## *DR's for Serial #*    **QXFA220**

# MAGNET DISREPAANCY REPORT

Part No: F10115641	Rev B	Traveler No.: AUP - 110	Rev: E
Part Name: QXFA COIL ASSEMBLY		Traveler OP No.: 1240	
Qty: 1	Ser. No./Lot No.: QXFA 220	Operation: Layer 1 Winding	
Initiator: Glenn Jochen		Life No.: 15764	Date: 12/09/2020
Type of Problem: (Check) Mechanical <input checked="" type="checkbox"/> Electrical <input type="checkbox"/> Other <input type="checkbox"/>

DR NUMBER: AM-191

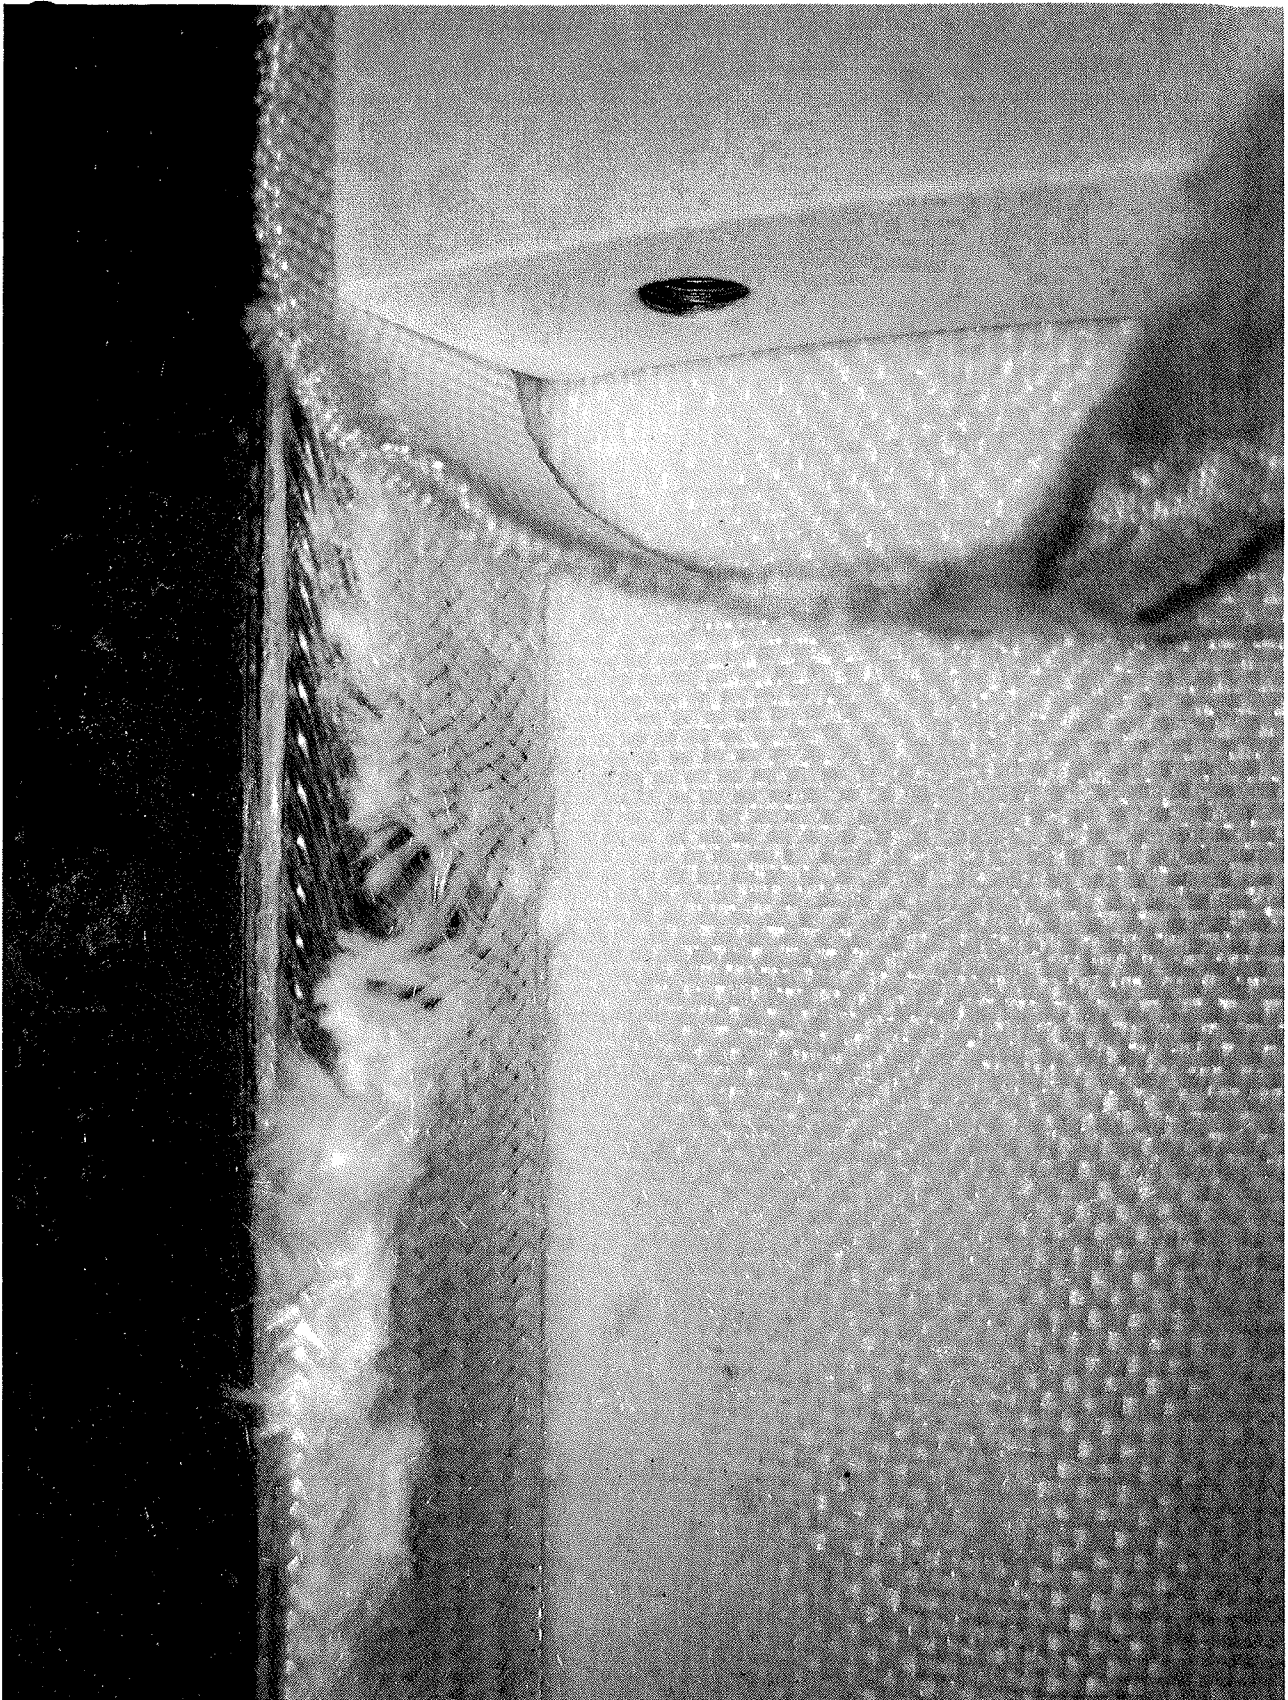
Description	Disposition <small>RWK, RPR, UAT, SCP</small>	CE	DQAR
Continue on reverse side if required			
Layer 2 coil lead insulation is chaffed along the major edge for ~ 1" adjacent to the lead end splice block. See sheet 2	RWK	<i>JS</i>	<i>[Signature]</i>

Instructions: Continue on additional sheets if required	Name	Life #	Date
SMOOTH OUT DISPLACED FIBERGLASS PRIOR TO REACTION.	<i>[Signature]</i>	15764

QXFA220 – Coil to pole short:

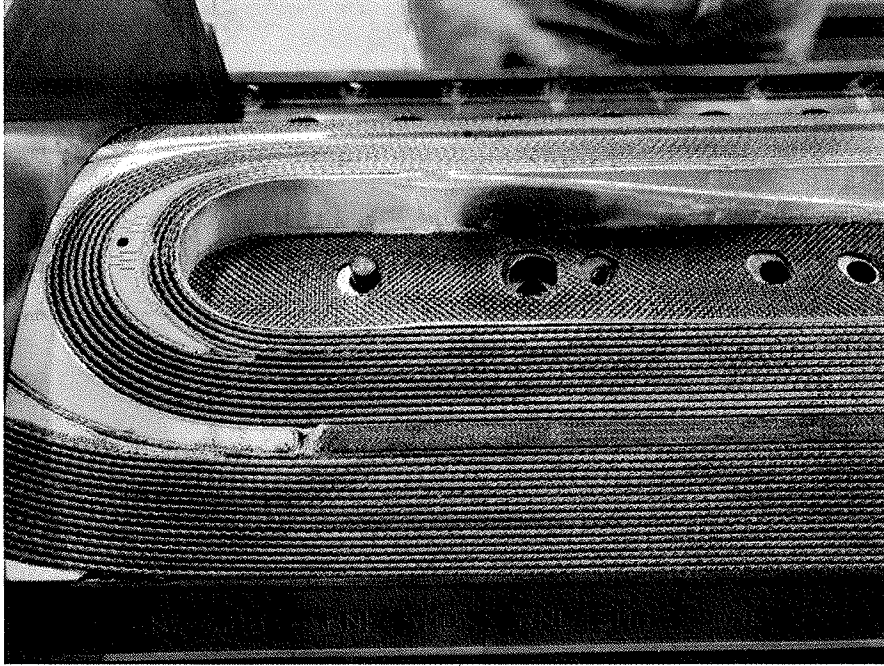
Description	Disposition <small>RWK, RPR, UAI, SCP</small>	CE	DQAR
Continue on reverse side if required			
Coil to pole short after reaction. Resistance of approx 380 Ohms measured during inner layer prep for impregnation. Area of short exhibits discoloration - See attached	RPR	9/5

1. Removed 1<sup>st</sup> and 2<sup>nd</sup> outer layer pole segments.

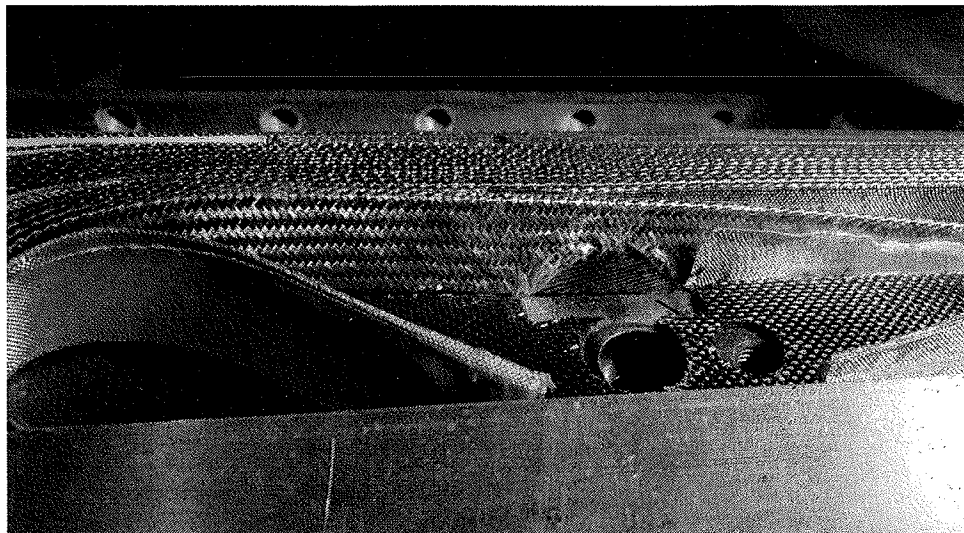
2. Removed contaminated fiberglass pole insulation.
3. Cut away contaminated area of interlayer insulation.
4. Cleaned up remaining residue.

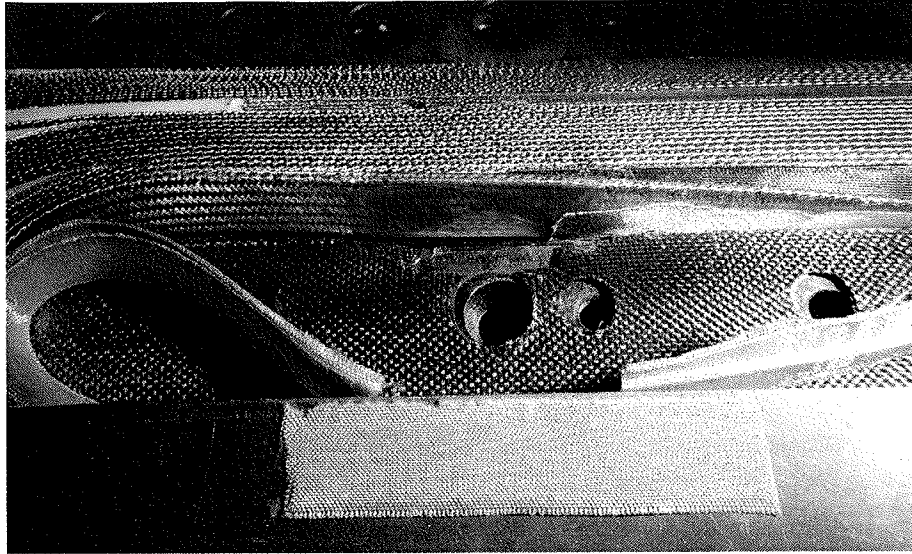
5. Inserted 2 mil Kapton between first turn and pole, also between IL first turn and OL 1<sup>st</sup> turn.

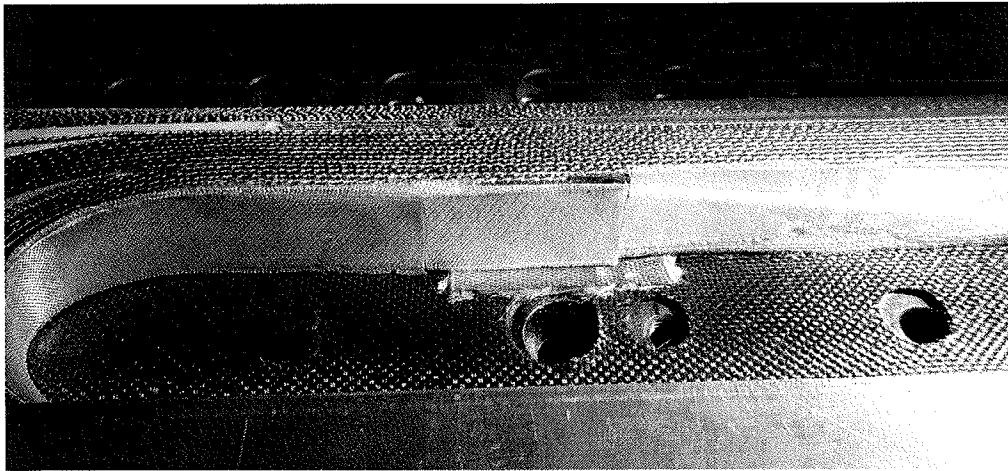
6. Installed new fiberglass where interlayer was cut away.
7. Installed new fiberglass pole insulation.

8. Reinstalled 1<sup>st</sup> and 2<sup>nd</sup> outer layer pole segments.
9. Proceeded with prep for impregnation.
